KOCH NITROGEN COMPANY LLC

**RE            Response to EPA November 21, 2012 Approval w/ Comment to the Phase II  
 RFI Work Plan Addendum: Tier II Soil Plan  
 Koch Nitrogen Company, LLC  
 Dodge City, Kansas  
 EPA RCRA ID No. KSD044625010**

**EPA 21 NOVEMBER 2012 COMMENTS  
AND KNC RESPONSES**

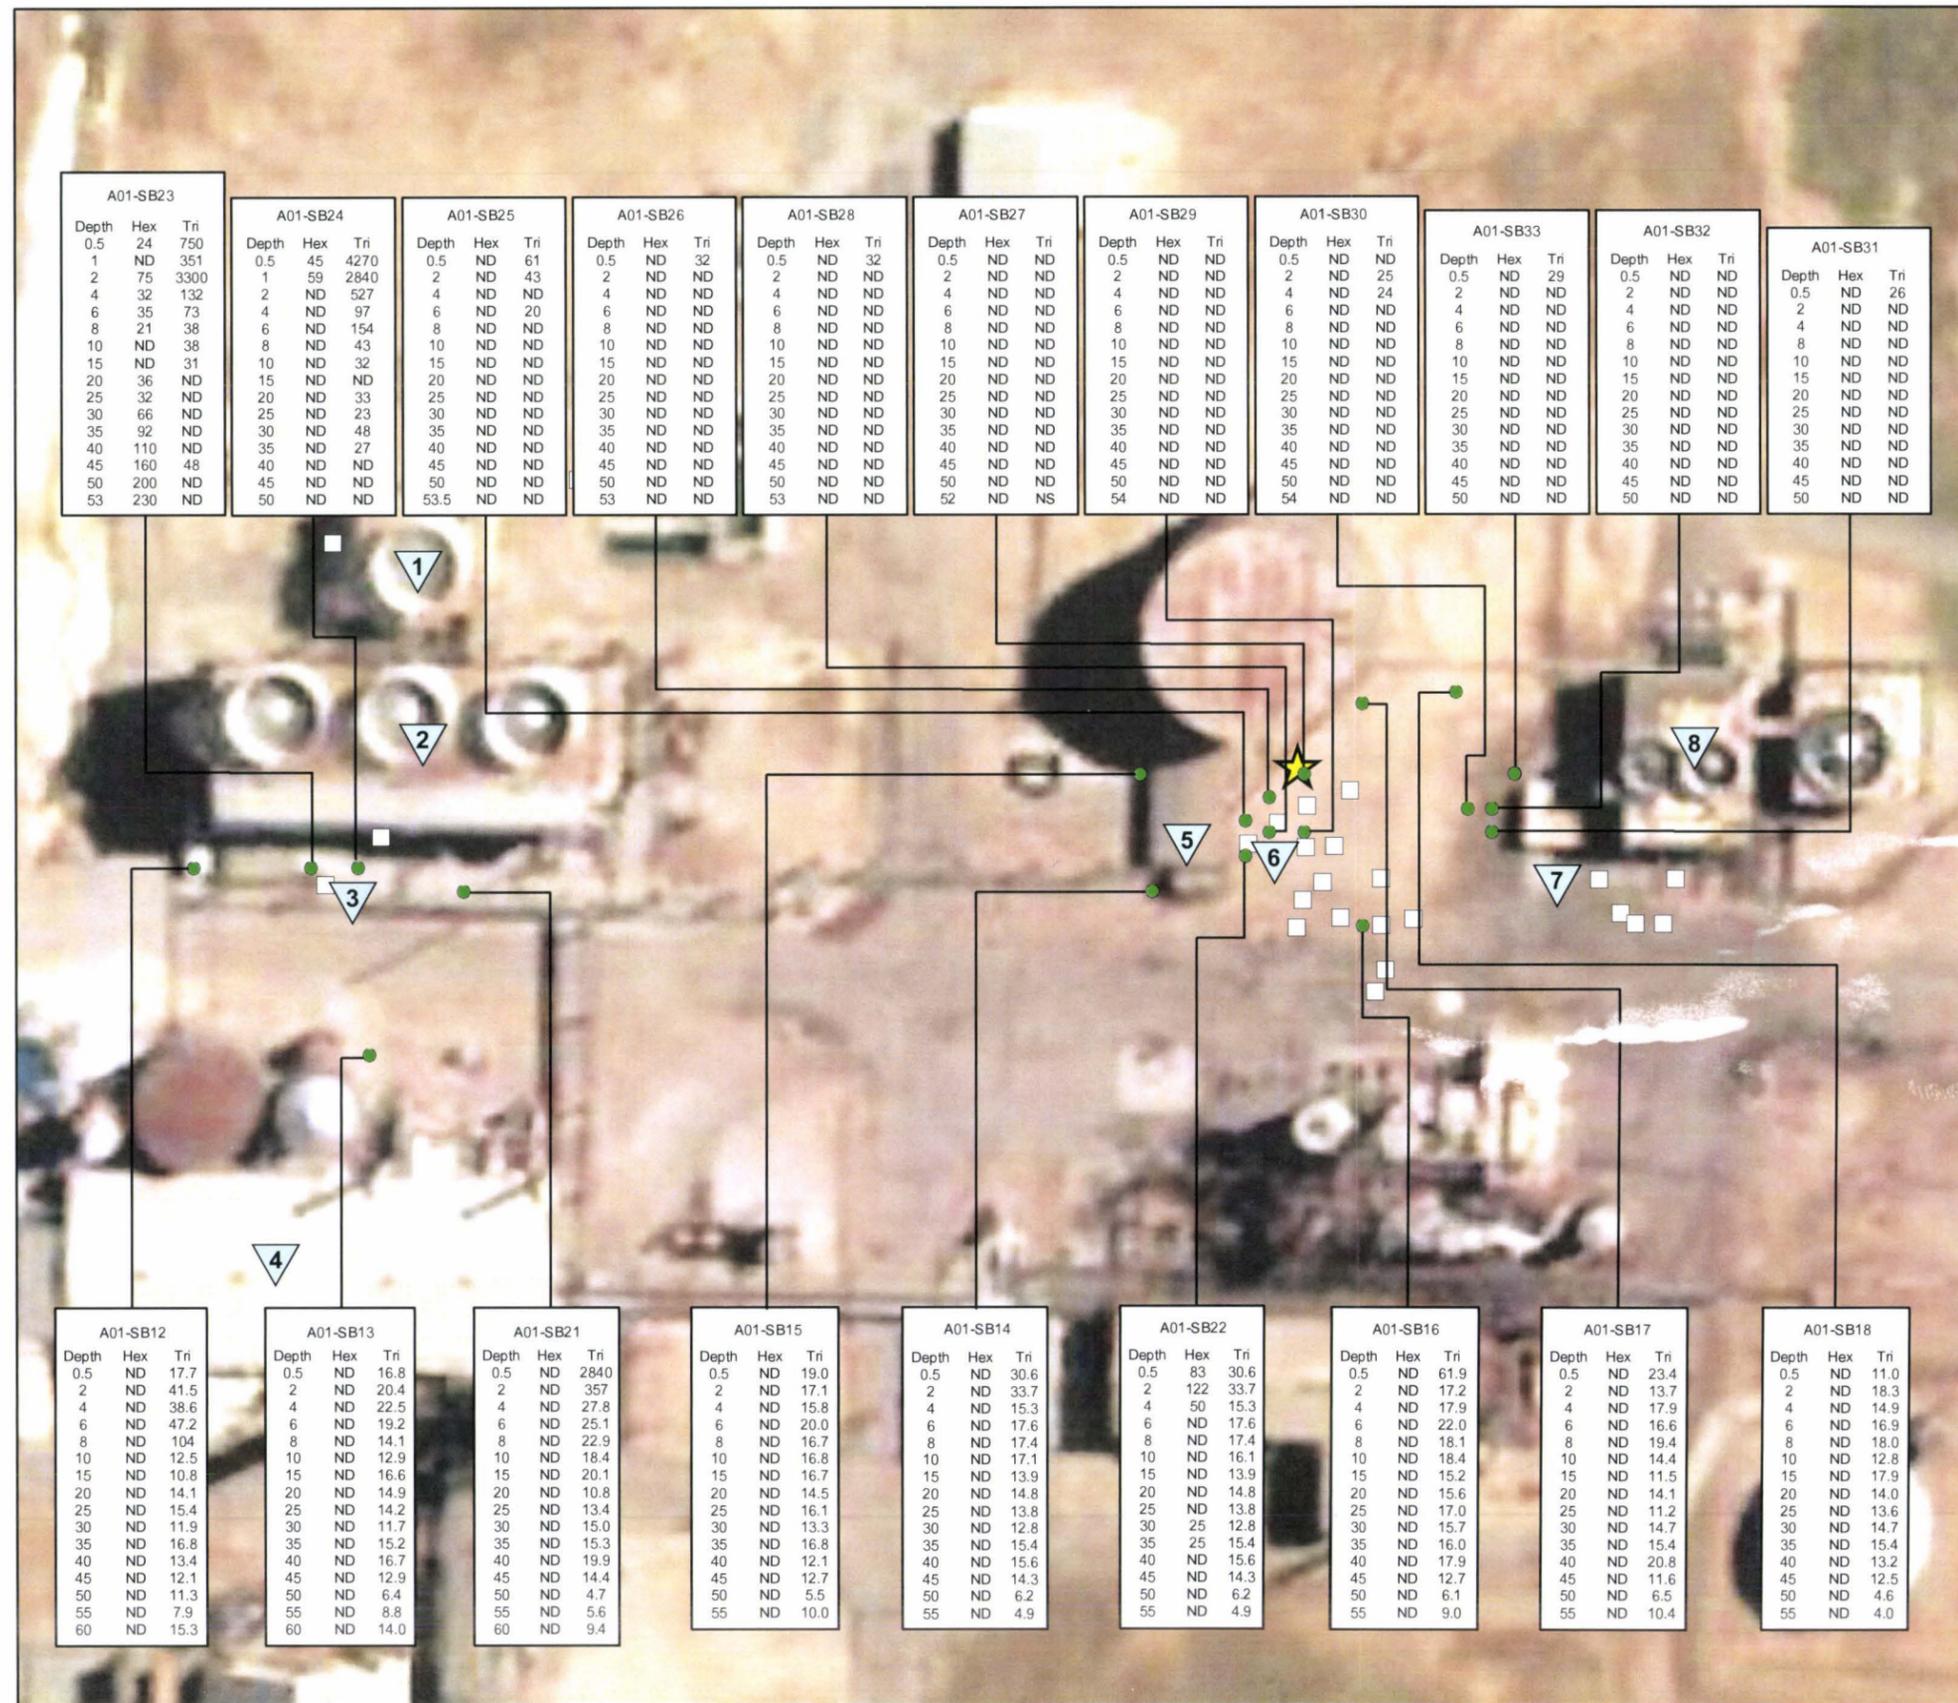
PM Comment 2 – Nitrate+Nitrite as N Soil Sampling, Page 4, Last Paragraph: Reference is made to installing three well clusters (MW-27, MW-28, and MW-29) previously identified in the Phase II RFI Work Plan Addendum: Groundwater Characterization (KNC, 2010b) after completion of the deep soil borings at locations S1K(Deep), S2K(Deep), and S2I(Deep). Please add a reference in this section to the Figure where the three well clusters (MW-27, MW-28, and MW-29) will be located/installed. Please submit a replacement page with the changes, and include the new Figure.

PM Comment 4 – *Section 3.0 Chromium Soil Sampling, Page 5, Third Paragraph, First and Second Sentences: Reference is made to deep borings S1KDeep, S2KDeep, and A1GDeep. Please add a reference to this paragraph that identifies the figure(s) where the deep borings will be located. Please submit a replacement page. Please see Geologist’s comment regarding A1GDeep below.*

**Response: Comment noted. A sentence has been added to the last paragraph of page 4 that reads, "The location of deep borings and monitoring wells is depicted on Figure 4." Attachment B provides text revision replacement pages. Attachment C contains the revised Figure 4 that includes the new well cluster name adjacent to the boring.**

**Response: Comment noted. A sentence has been added to the last paragraph (after the second sentence) that reads, “The location of these borings and proposed wells is provided on Figure 4.” The replacement text is provided in Attachment B and the revised Figure 4 is provided in Attachment C.**

PROJECT NO.	FIGURE NO. 2
DATE. DECEMBER 2012	FILE NO.

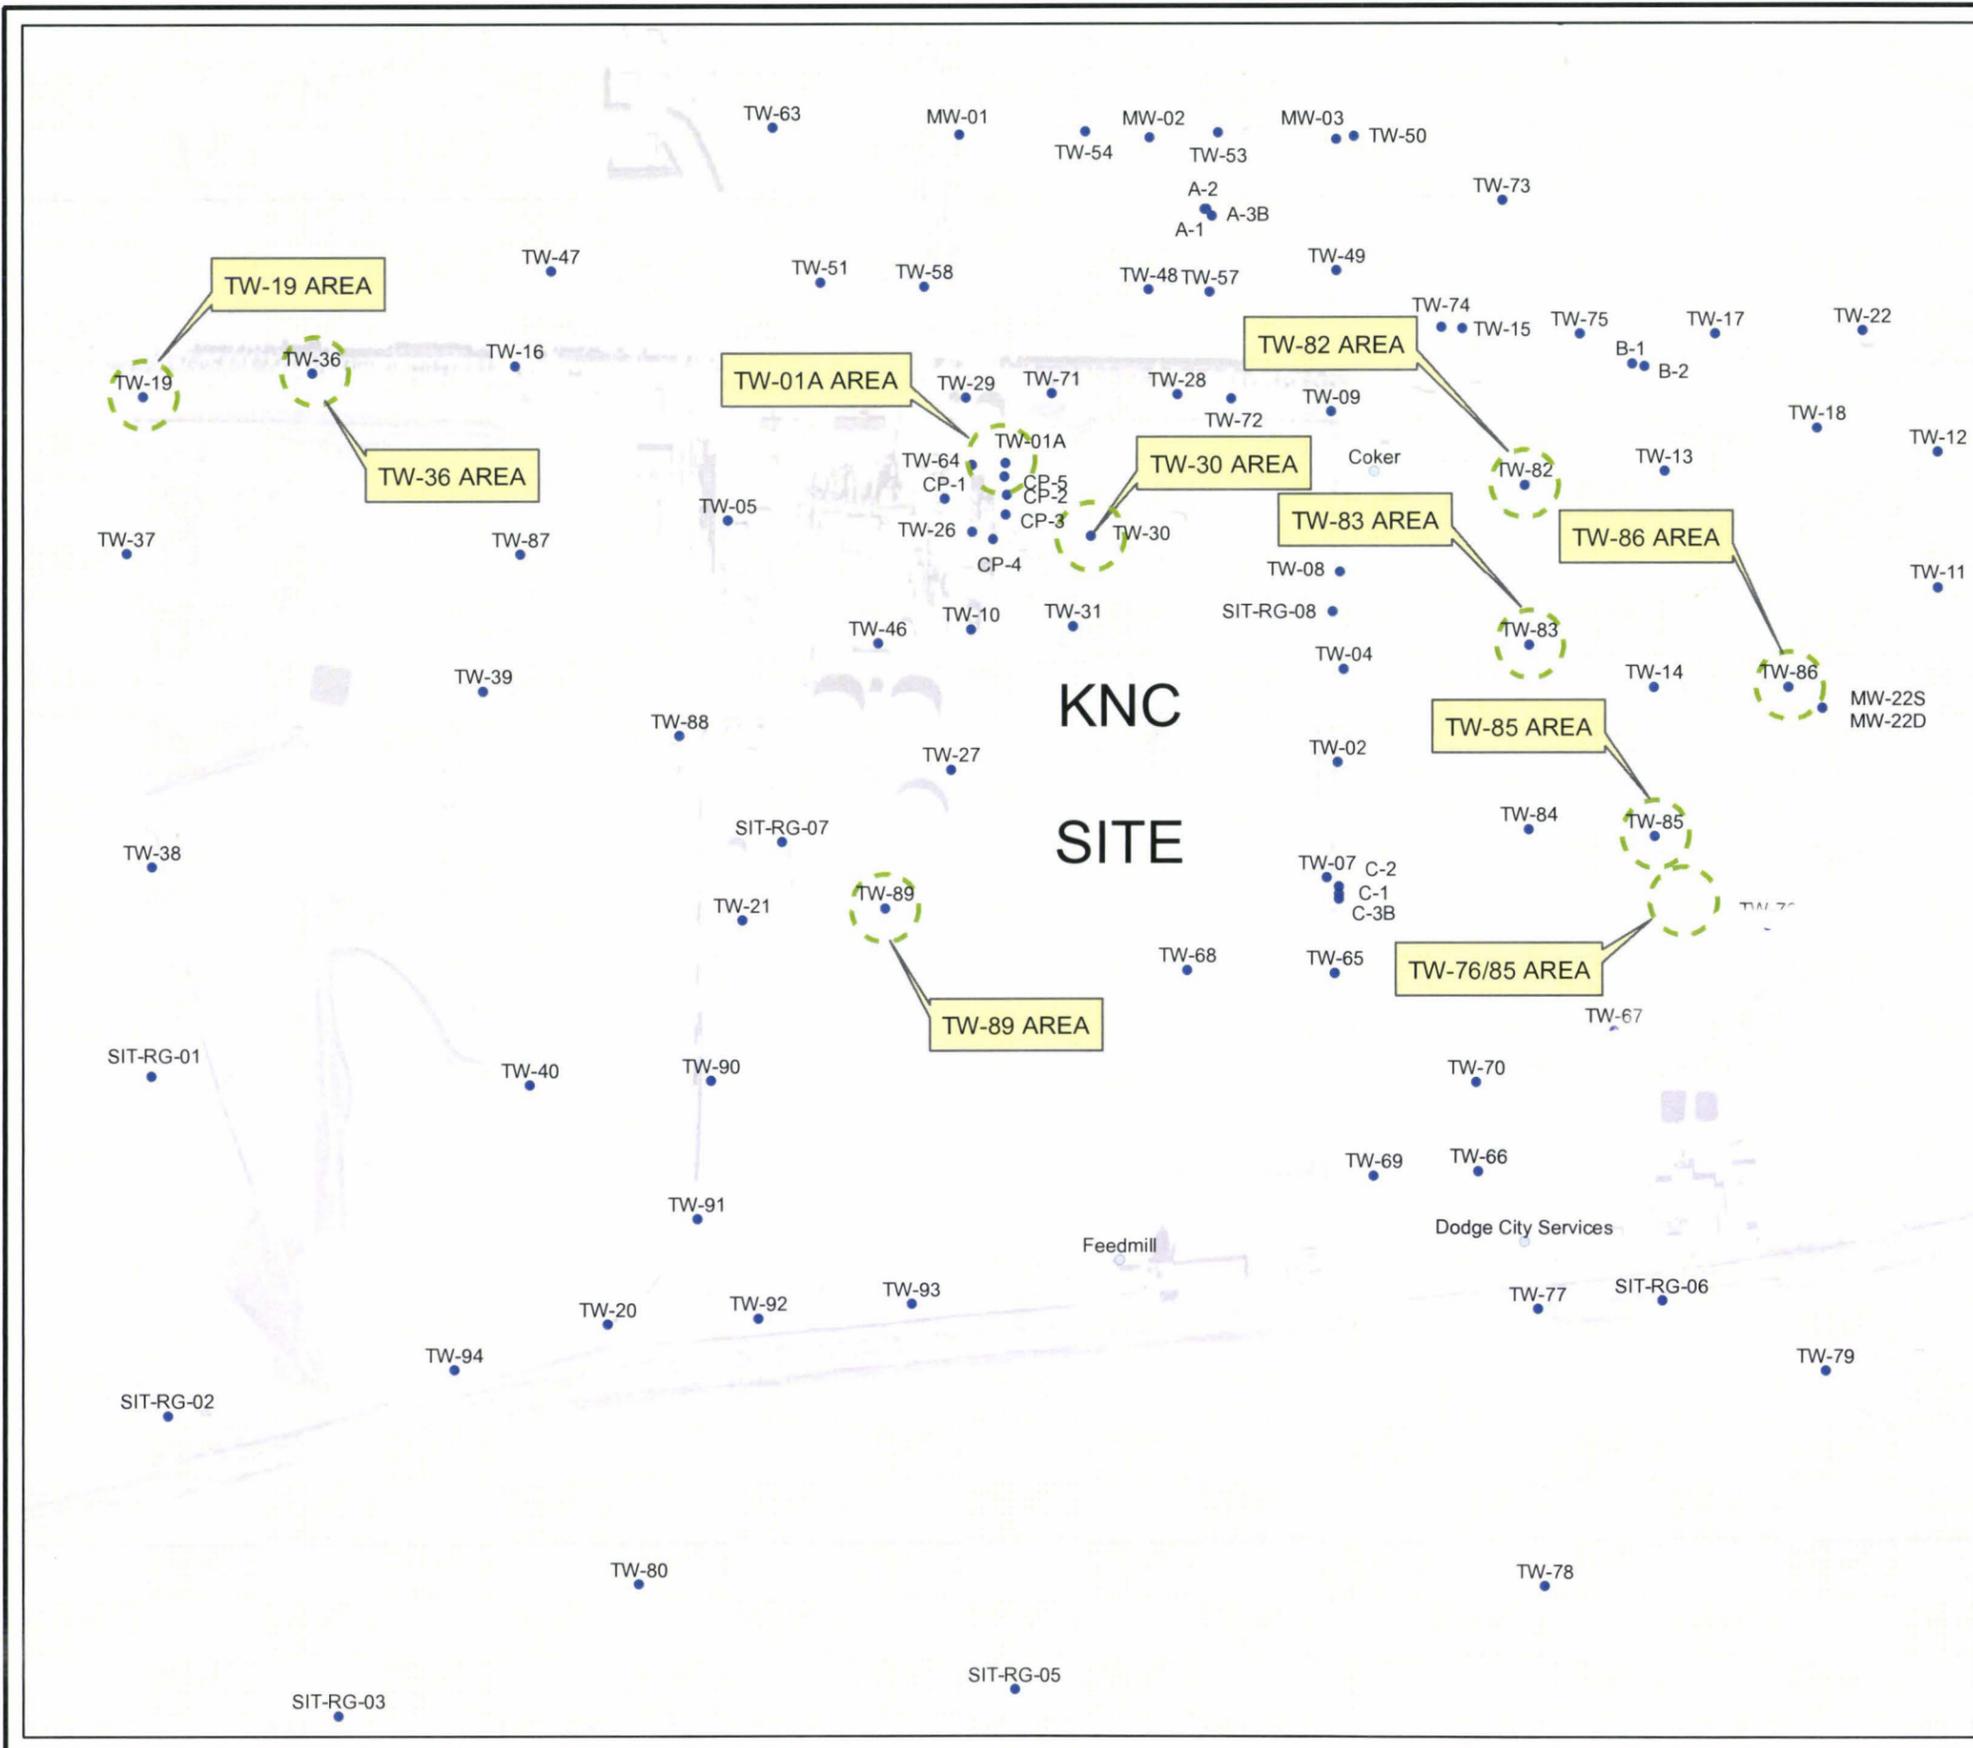
*Geologist Comment A – The location for A1GDeep is shown on Figure 4. Please also show its location on a larger scale figure of AOC-1 such as Figure 2.*

*Geologist Comment D – The EPA believes the extensive characterization of the distribution of hexavalent and trivalent chromium as proposed by Koch will be very valuable. The EPA believes that locating the borings as close as possible to the largest spill of chromic acid will provide “worst case scenario” information regarding AOC-1 and provide valuable information to support a final remedy decision. The EPA is aware of the problems of locating any borings in AOC-1 due to the active processes in the area as well as the presence of utilities, and is only recommending location the boring near the major spill within the physical constraints of working in this area. Also, it would be very helpful if Koch would also illustrate on the large-scale figure requested above the locations of the historic spills of chromic acid/sodium dichromate.*

**Response: Comment noted. A revised Figure 2, which identifies the proposed location of A1GDEEP is provided in Attachment C. Please note that, as discussed during our 15 June 2012 meeting, access in this area is limited due to the presence of above and below-ground structures and KNC may adjust the exact position of this boring as field conditions warrant.**

**Response: Comment noted. The proposed location of A1GDEEP in revised Figure 2 (Attachment C) represents KNC’s best effort to site this well to meet the EPA’s objective within site constraints. To KNC’s knowledge, the approximate location of chromic acid/sodium dichromate spills by the previous owner are identified in the legend for Figure 2 as follows: i.) Triangle with 3 - Pipe Leak Location; ii) Triangle with 6 - North chromate tank location; and iii.) Triangle with 7 - South chromate tank location.**

PREPARED BY:	
 <small>KOCH NITROGEN COMPANY 11599 US HIGHWAY 50, P.O. BOX 1337 DODGE CITY, KS 67801</small>	
PROJECT:	FIGURE NO. B-4
DATE: DECEMBER 2012	FILE NO.

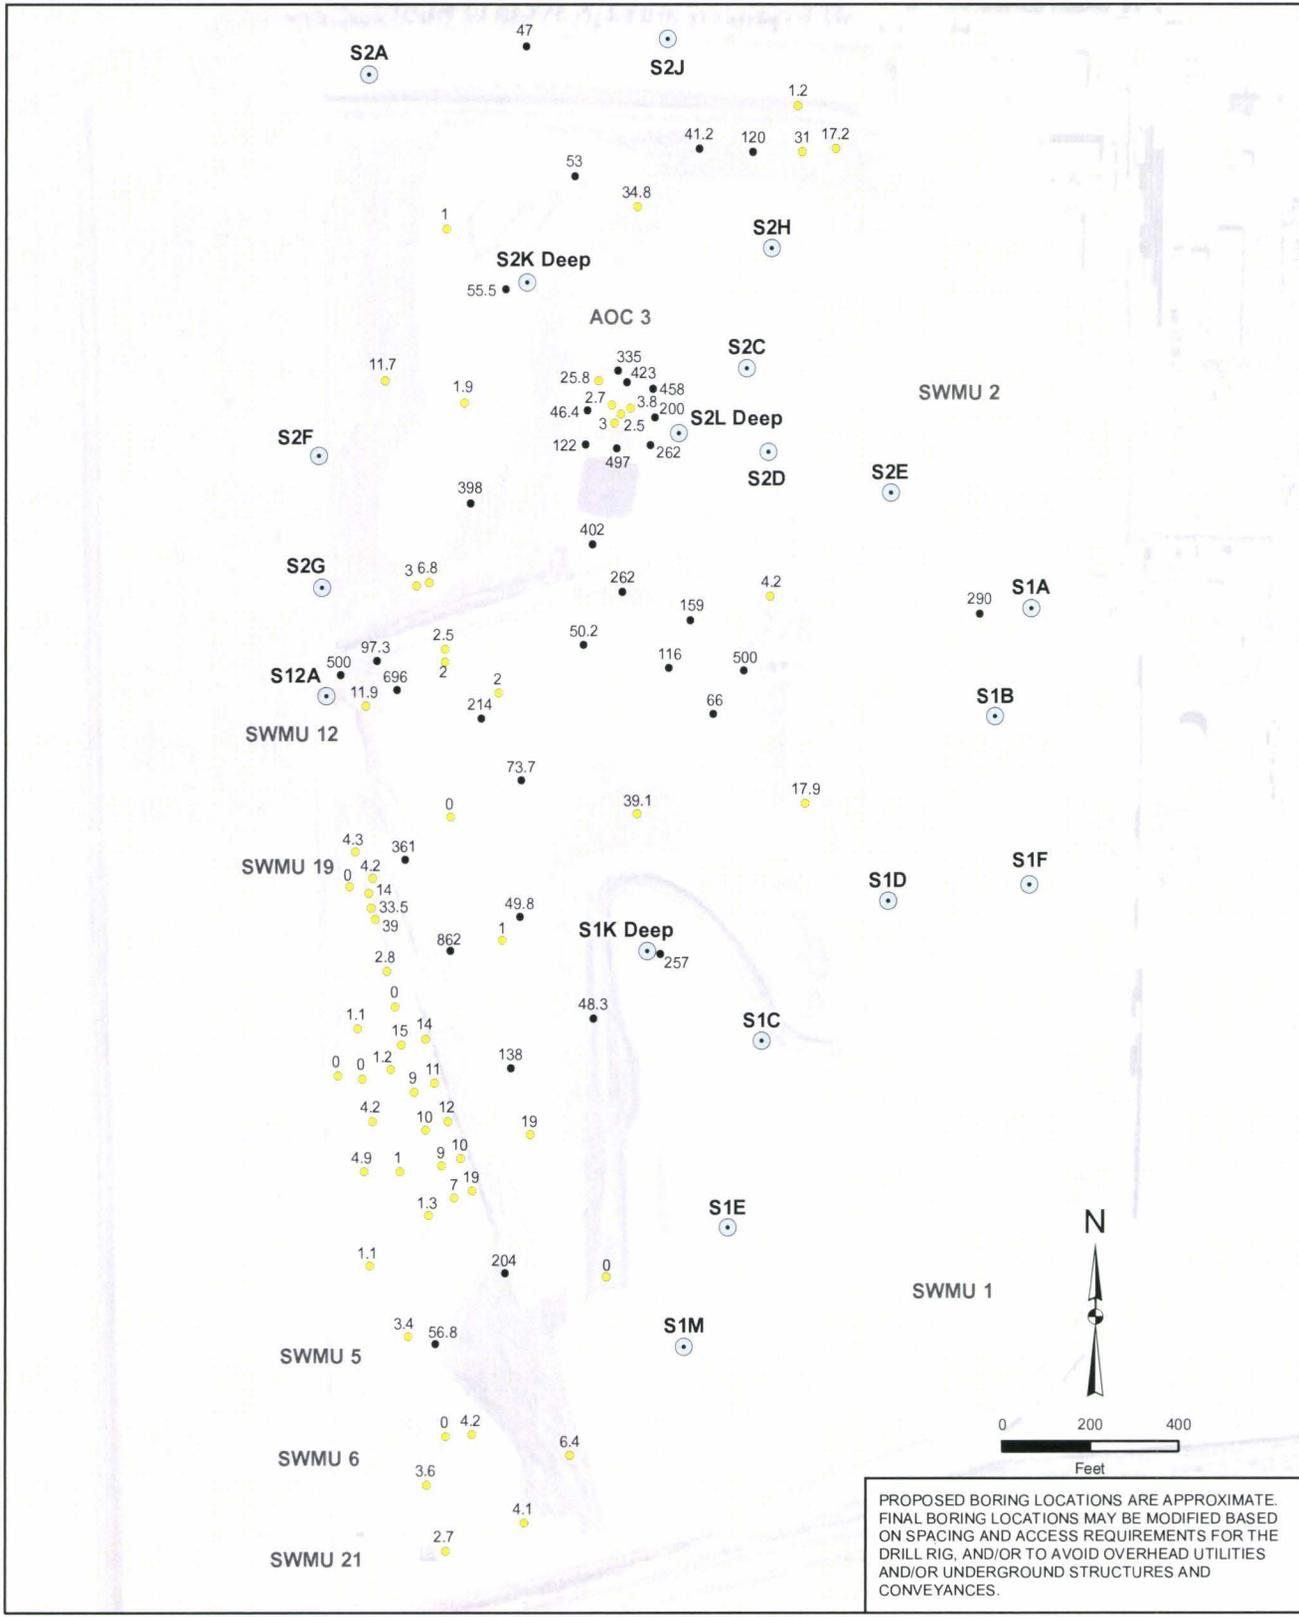
Figure	Constituent	Missing Sampling Locations
B-4	Nitrate+Nitrite (as N)	Between S2I and S2F; straight out from the 93.1 level of N.
B-5 and B-6	Nitrate+Nitrite(as N)	Sampling locations S1F was

- **Figure B-4 – Figure has been revised to include this sampling point and is included in Attachment D. Table 1 (Attachment E) has also been revised to reflect the addition of Nitrate+Nitrite as N analysis at his location.**
